BRUCE PLACE SUBDIVISION

The plat illustrates the proposed $1.49\pm$ acre, 1-lot subdivision which is located on the Northeast corner of Old Shell Road and Fairway Avenue, and is in Council District 7. The applicant states that the subdivision is served by both public water and sanitary sewer.

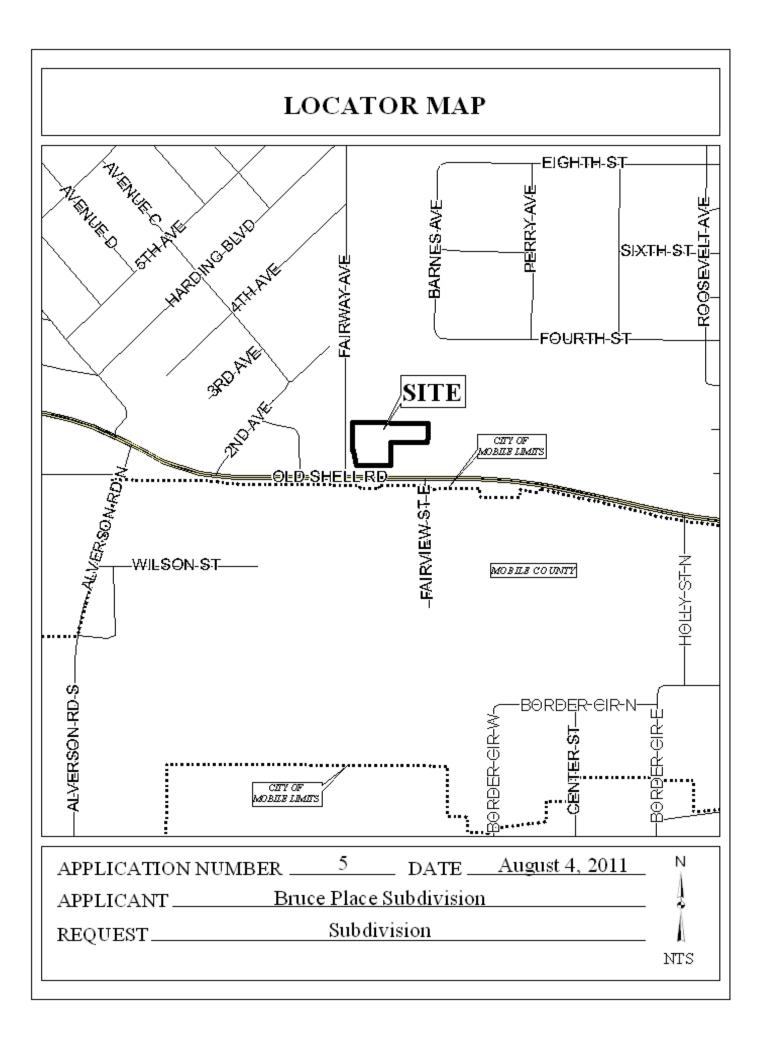
The purpose of this application is to create a one lot subdivision from two metes and bounds parcels and a legal lot of record. Lot size is not labeled, however the proposed lot would meet the minimum size requirements of Section V.D.2. of the Subdivision Regulations. The lot size should be included in acres and square feet on the Final Plat if approved.

The 25-foot minimum building setback line, required in Section V.D.9., is not illustrated on the preliminary plat, and should be shown for all right-of-way frontages on the Final Plat, if approved.

- 1) depiction of the 25-foot minimum building setback line along all right-of-way frontages;
- 2) the labeling of the lot with its size in square feet and acres, or placement of a table on the plat with the same information;
